MCDONALDS RESTAURANT

**Re: Construction Storm Water Inspection at McDonalds Restaurant / Franklin County  
Permit Number: 4GC03466 \*AG**

Figure 1: Uncovered storm drain

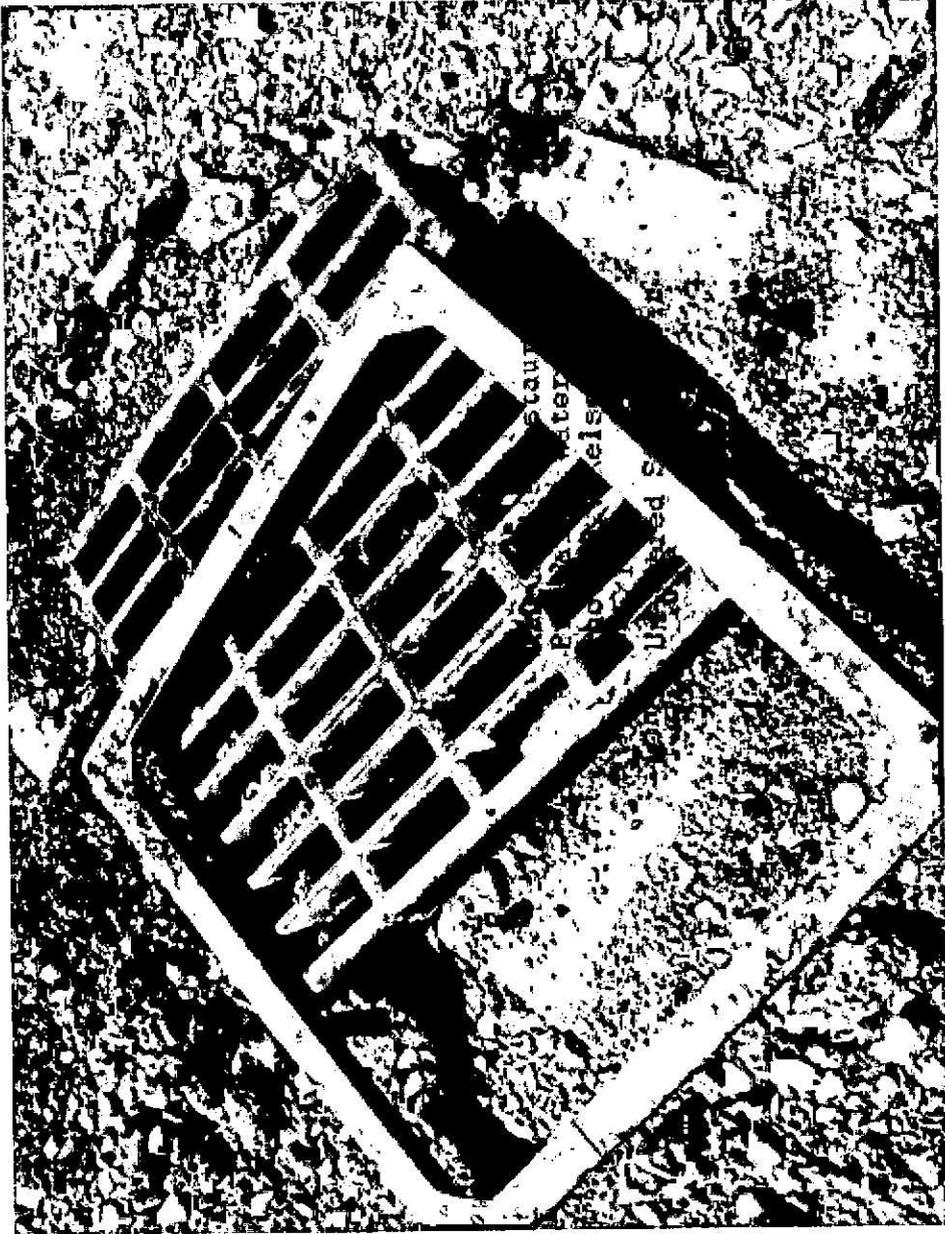
- Our staff noted an uncovered storm sewer drain which requires appropriate inlet protection. (See Figure 1).
- Silt fence must be installed around the entire perimeter of the site.
